# Final TAB Punchlist

**5774 Burlington (IA) FSU**

241 Legacy Dr, Burlington, Iowa

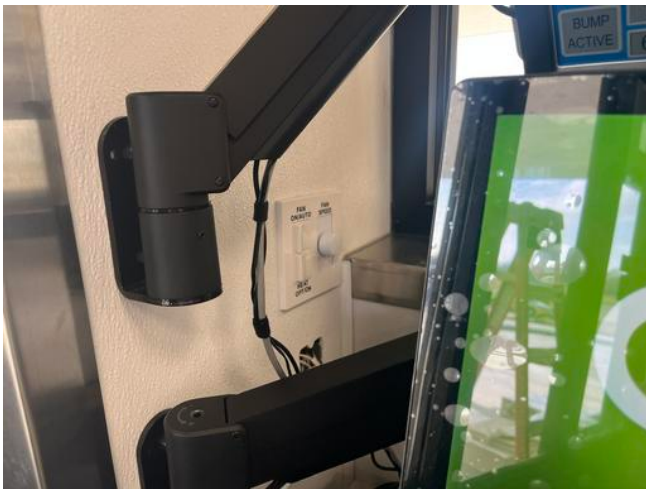
Air curtain magnetic door switches are not installed correctly or not properly controlling mode activation in Auto at time of TAB inspection.

IMG\_0437

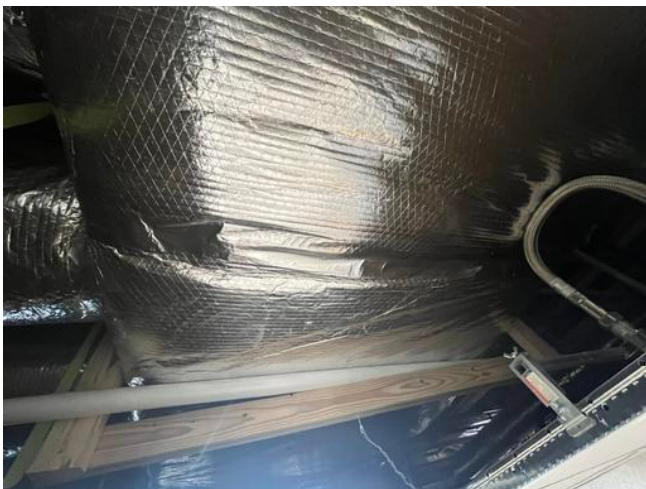
External insulation on bottom of ducts 24" or wider is to be supported by stick pins 18" on center. Cut pins and apply tape or mastic over stick pin washers.

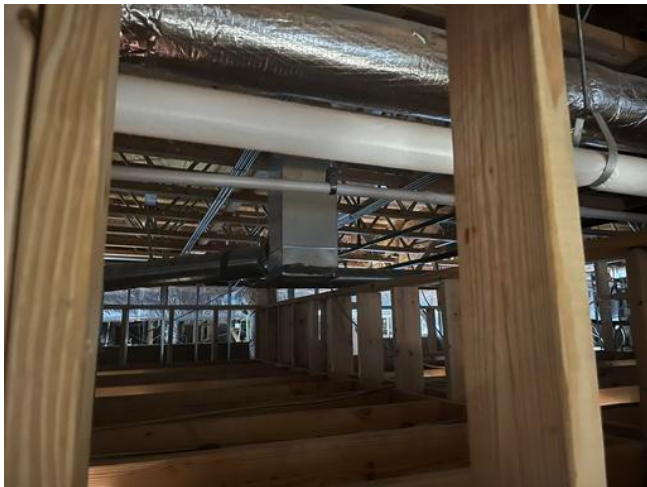
Restroom round exhaust duct is to be externally insulated to mitigate noise per mechanical specifications.
